CM CLARIFICATION #004

PROJECT: CNE Tahlequah Casino

ADDENDUM # 001

Tahlequah Casino Addendum #01 summary

SHEET NUMBER: **S1.2**

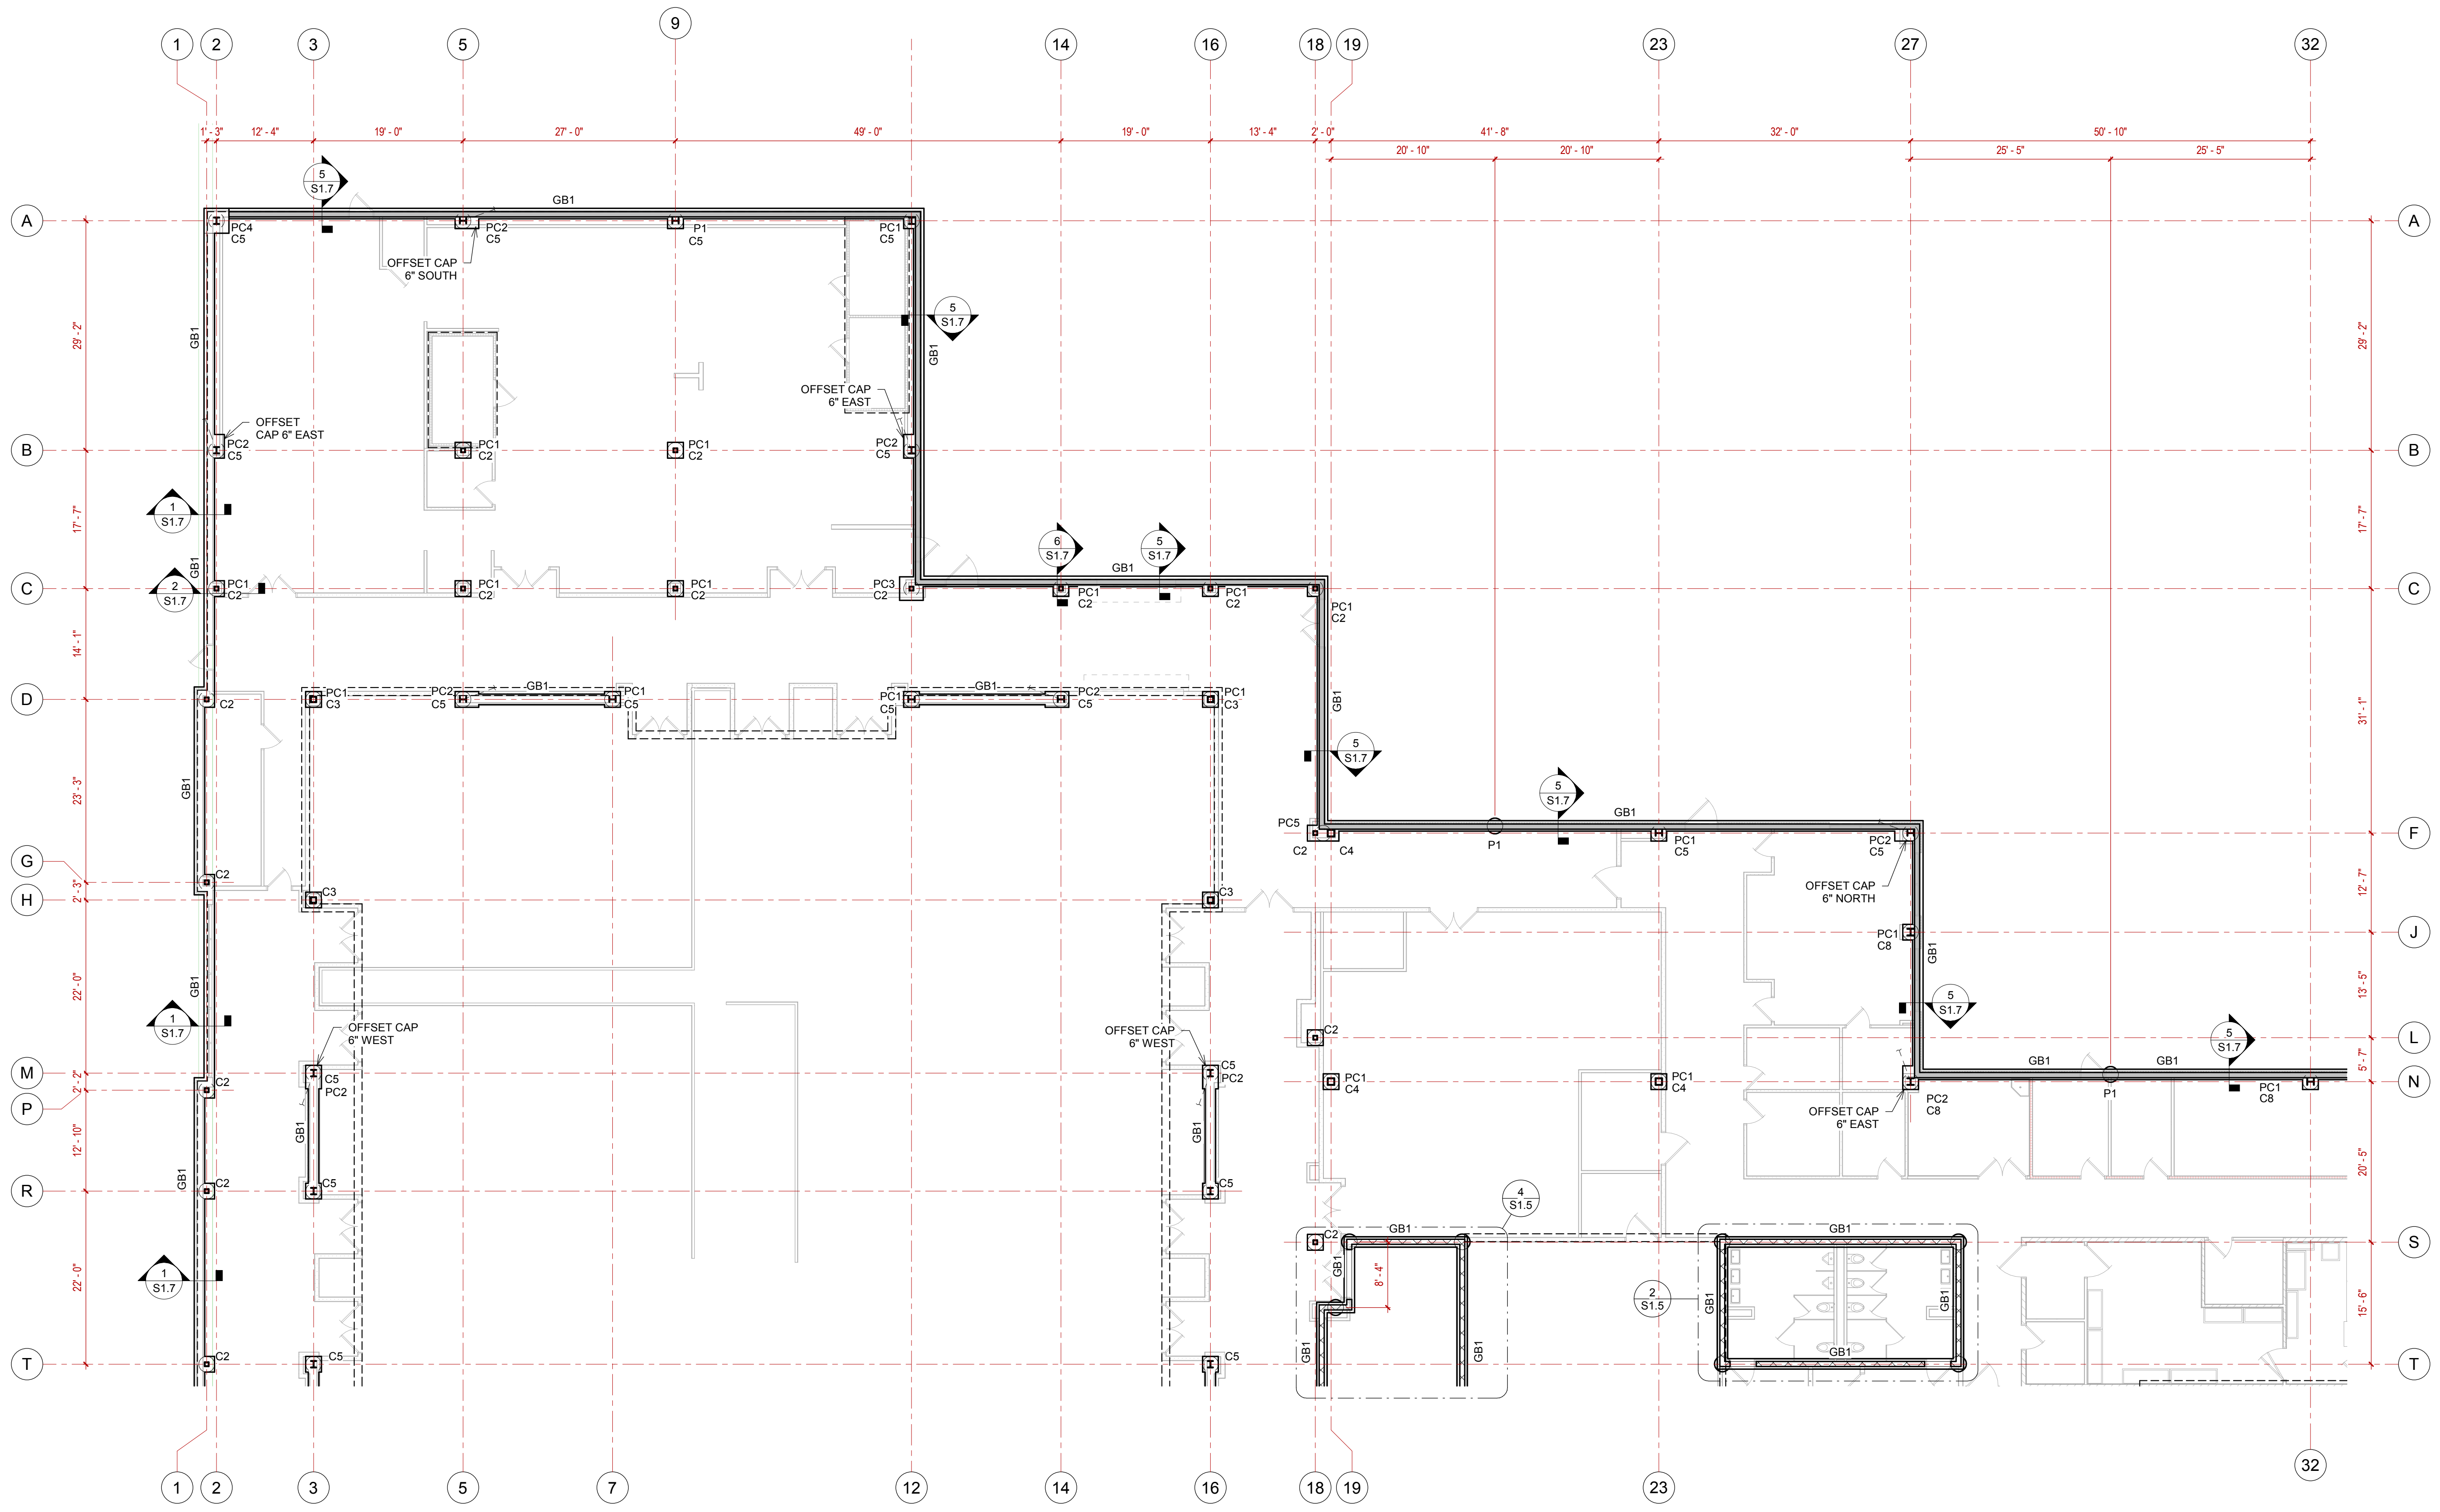
Sheet No.	Addendum
S1.2	<ul style="list-style-type: none"> • Added Grade beam, pier cap, & column schedules to sheet. • Added Grade beam, pier cap, & column marks to plan. • Added Callouts for safer room foundation plans • Stepped grade beam and added curb to back of house for drainage access. • Added section marks to plan. • Changed all HSS6x6x3/16 columns to HSS6x6x1/4
S1.3	<ul style="list-style-type: none"> • Added Grade beam, pier cap, pedestal, & columns schedules to sheet. • Added Grade beam, pier cap, pedestal, & column marks to plan. • Added callouts for safer room foundation plans. • Stepped grade beam and added curb to front of house at sub floor locations. • Moved details to sheet S1.6 & S1.7 • Added section marks to plan. • Removed pier and column at grid U-19 & U-27 • Moved grid 'DD' 1" East
S1.4	<ul style="list-style-type: none"> • Added Grade beam, pier cap, pedestal, & columns schedules to sheet. • Added Grade beam, pier cap, pedestal, & column marks to plan. • Added callouts for safer room foundation plans. • Stepped grade beam and added curb to front of house at sub floor locations. • Added section marks to plan. • Removed pier and column at grid E-44
